Equipment Technical Bulletin

DR-2000: New 3-Pin Wire Harness on Main PCB

DR-2000 Main PCB.

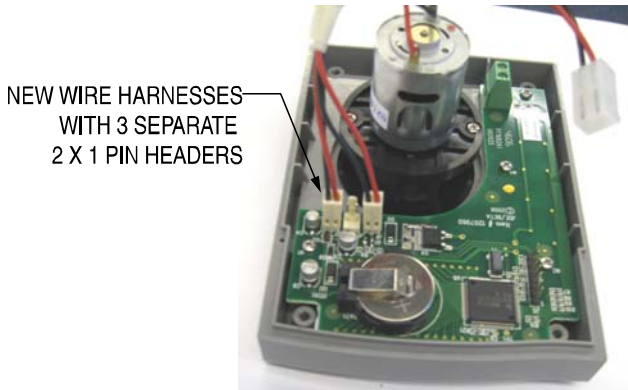
Part number 1202397 (DR2 Main PCB) whose wire harness previously had a single 6 x 1-pin header now has 3 separate 2 x 1 pin headers. This is important to note because these new harnesses (when purchased as spares) will not work on PCB's that used the older harnesses. However, old harnesses will work with new PCB.

If you keep stock of these harnesses as spares, make sure that you do not pair a new harness with a PCB that previously had the 6 x 1-pin header harness.
